Bulk Variance Application No. ZB-1/25

Jitesh Patel, 6 Morrell Road

Tax Map Page 52.02, Block 5201.09, Lot 3

**Bulk Variance Relief**

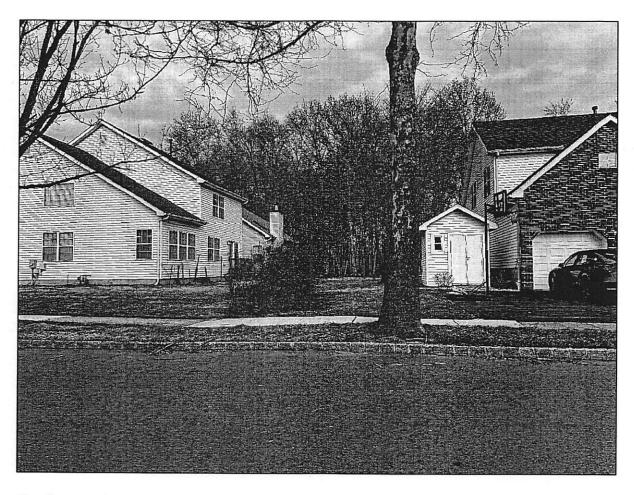
Relative to the first prong of the negative criteria, the rear of the dwelling and addition face the side of the dwelling on Lot 4 to the south. The picture on the following page shows the relationship between the two structures, and the addition will be within 8.5' feet of the common property line. The shed on adjacent Lot 4 is approximately 17' from the property line and the main structure is approximately 30' from the property line. Based on the plans submitted, it does

not appear there are any windows on the south elevation of the addition. Landscape screening should be considered to address any potential visual impact to Lot 4. As to the second prong of the negative criteria, the Board will need to be satisfied that the intent of the setback standards, mainly the provision of adequate light, air and open space, is not substantially impaired by the grant of relief in this instance.
